From: Sarah Featherstone [REDACTED]
Sent: 27 September 2019 10:04
To: Anita Gardner <Anita.Gardner@arun.gov.uk>
Cc: Martyn White <Martyn.White@arun.gov.uk>
Subject: Thatch Cottage applications CM/42/19/PL and CM/43/19/L

Thatch Cottage:

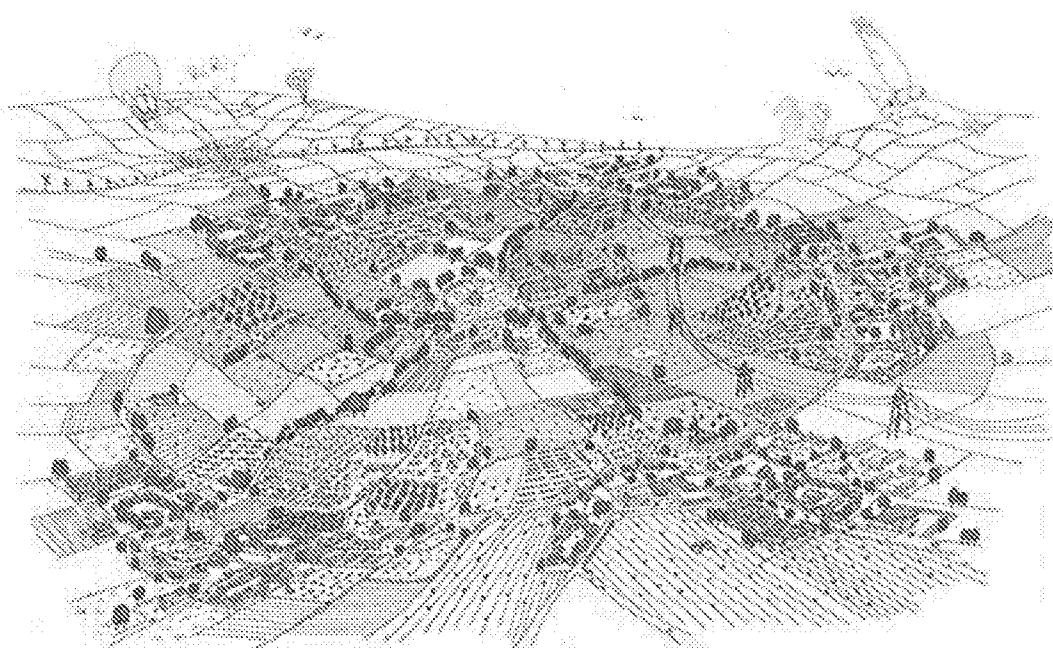
- Shutter details: Window 9 - proposed storm window - we stated "looks better if openings flush with window frame" — MW states "this is matter of detail" . We will provide a detail. Windows 3 & 4 - we understand MW not clear how the shutters operate - they slide in front of external wall. We will provide detail.
- Detail of stone paving specification on external terrace.
- Simple landscape of external garden if required, see note above.
-
- **3. Samples:**
- the side of south terrace ramp is shown faced in brick where it is above grassed ground. The brick will match existing brick quoins. Is it necessary to make up a sample panel for such a small area it is flush to ground at one end and rises above ground to a max height of 300mm at other end?

- We confirm all windows have shutters.
- No wall to to edge of southern terrace, there is brick faced side to ramp where it is above grassed ground.
- Private garden - this is not enclosed but Thatch Cottage terraced area opens on to it so we envisage it being used primarily by Thatch Cottage occupants. It will be grassed so we did not think a landscape scheme would be required. Please confirm.
- MW states that the repair and replacement of thatch roof will be acceptable if it reflects those on the existing roof. We can confirm we submitted a Thatch Methodology Statement with the application which confirms the replacement thatch will match what is there on the existing roof. Please confirm no further information is required.
-
- **2. Additional details which we can issue next week:**
- T&G board detail used on external wall cladding of new extension
